COUNCIL ASSESSMENT REPORT

Panel Reference	2019ECI009
DA Number	DA-2014/319/C
LGA	Bayside Council
Proposed Development	Modification to leaf-stream screens to re-align with balcony and accessible locations
Street Address	213 Princes Highway and 4 Wardell Street, Arncliffe
Applicant/Owner	Council to complete
Date of DA lodgement	20 December 2018
Number of Submissions	Nil
Recommendation	Approval
Regional Development Criteria (Schedule 4A of the EP&A Act)	Clause 3 Capital Investment Value of the initial proposal exceeds \$20 million.
List of all relevant s79C(1)(a) matters	<ul style="list-style-type: none"> • Section 4.56 of the Environmental Planning and Assessment Act, 1979 • Section 4.15 of the Environmental Planning and Assessment Act, 1979 • Rockdale Local Environmental Plan 2011 • SEPP 65 and Apartment Design Guide • Rockdale DCP 2011 • No changes to planning agreement entered into under Section 7.4, • Environmental Planning and Assessment Regulation 115

RALAN Arncliffe - Modification of Development 213 Princess Highway & 4 Wardell Street Arncliffe

Prepared for Bayside Council by GMU, 4th of April 2019

Fig. 2. The southern elevation as approved (Comparison Study prepared by EJE & DBI)

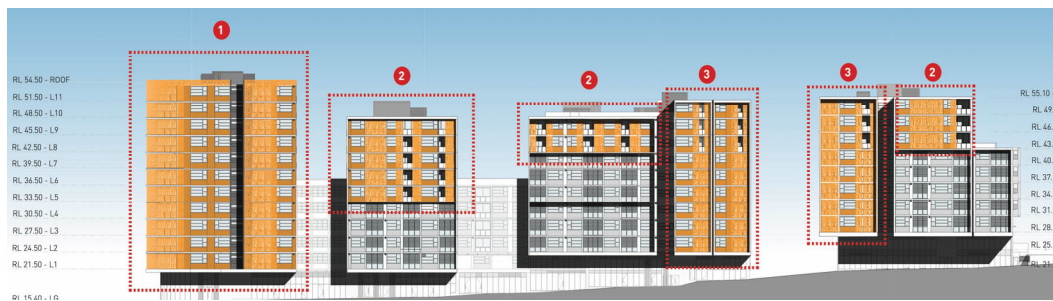
Fig. 3. The southern elevation as proposed (Comparison Study prepared by EJE & DBI), showing the reduction in leaf-stream panels

Relevant ADG principle	GMU comments
	<p>The proposed modifications result in a reduction in the adjustable leaf-stream screens to significant portions of the facades compared to the approved. The outcome of the proposed modification removes a number of screens to expose the façade however, where the screens are removed, the external cladding system is replaced with metal panels with expressed joints. This will ensure a dynamic expression to the façade and allow the different building forms to be defined individually to break up the perceived scale of the development in response to the existing and future context.</p> <p>To adequately address and complement the existing and future context of the site, the proposed modifications provide metal cladding panels to match the colour of the leaf screens to articulate the form, mitigate the scale of the development and complement the context. The recommended adjustment is listed in Part 7 of this report (Recommendation) and will ensure that the proposal can satisfy Principle No. 1 whilst addressing the practical concerns relating to the screens.</p>

- i. **The box framed element is to protrude at least 300mm beyond the plane of the screens and balustrades for the tower element of Building C facing Princess Highway (as approved); and**
- ii. **The box framed element is to protrude at least 150mm beyond the plane of the screens and balustrades the tower element of Building D facing Princess Highway (as approved); and**
- iii. **Metal panels with expressed joints are to be provided where the leaf screens are removed. The metal panels must be coloured to match the leaf screens (in accordance with Proposed DA 203 Elevation A, Proposed DA 208 Elevation F in Appendix A).**

Fig. 4. The northern elevation as approved (Comparison Study prepared by EJE & DBI)

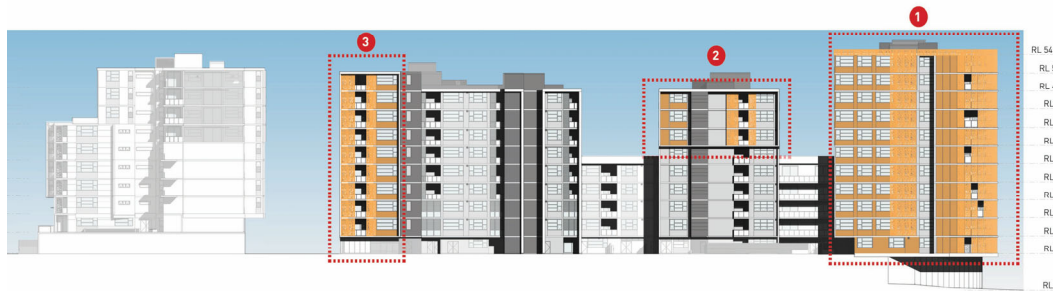
Fig. 5. The northern elevation as proposed (Comparison Study prepared by EJE & DBI), showing the proposed modification

Relevant ADG principle	GMU comments
	<p>cladding panels have expressed joints to add texture and emphasise the tower forms.</p> <p>To the northern elevation, the modifications result in reduction in the dynamic elements of the adjustable screens however, the metal panels to match the tones of the leaf-stream screens ensure a visually compelling contribution to the streetscape.</p> <p>The intended outcome of the approved condition was to ensure clarity in the visual hierarchy, expressing the slender tower forms as the prominent forms in the elevational profile. To mitigate the length of the development, the towers are articulated as the dominant forms. The proposed modifications ensure that the scale of the development is visually mitigated to compensate for the extensive length of the building form and insufficient built form articulation.</p> <p>Providing the proposed modification is in accordance with the recommended outcomes listed in Chapter 7 of this report, the proposal can satisfy Principle No. 9 of the ADG.</p>

Fig. 6. Photomontage showing the approved proposal (by EJE & DBI)

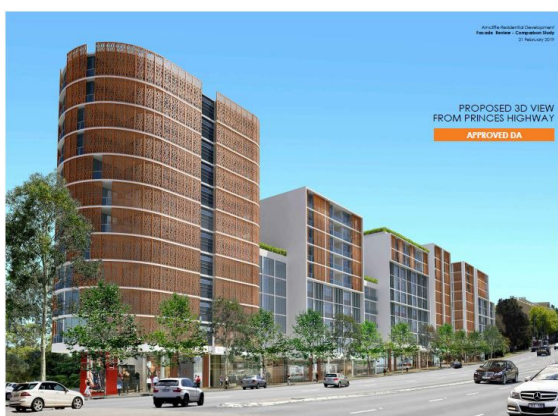
According to the Façade Review Comparison Study (prepared by DBI & EJE architects, dated 25th of March 2019) provided by the applicant (Appendix A), the expressed box-framed structures articulating the tower forms appear to be decreased in depth, when compared to the approved. The lesser depth of the framing element further detracts from the articulation of the tower forms and the intended visual hierarchy.

We understand that the approved scheme was not accurately depicted in the photomontage provided (Fig 6 below). Given the proposed amendments to the façade, GMU consider it essential to ensure visual definition and depth to the box frame elements, to compensate for the significant reduction in the number of screens. The box framed tower elements facing Princess Highway should provide a minimum protrusion in accordance with the recommended outcomes listed in Chapter 7 of this report.
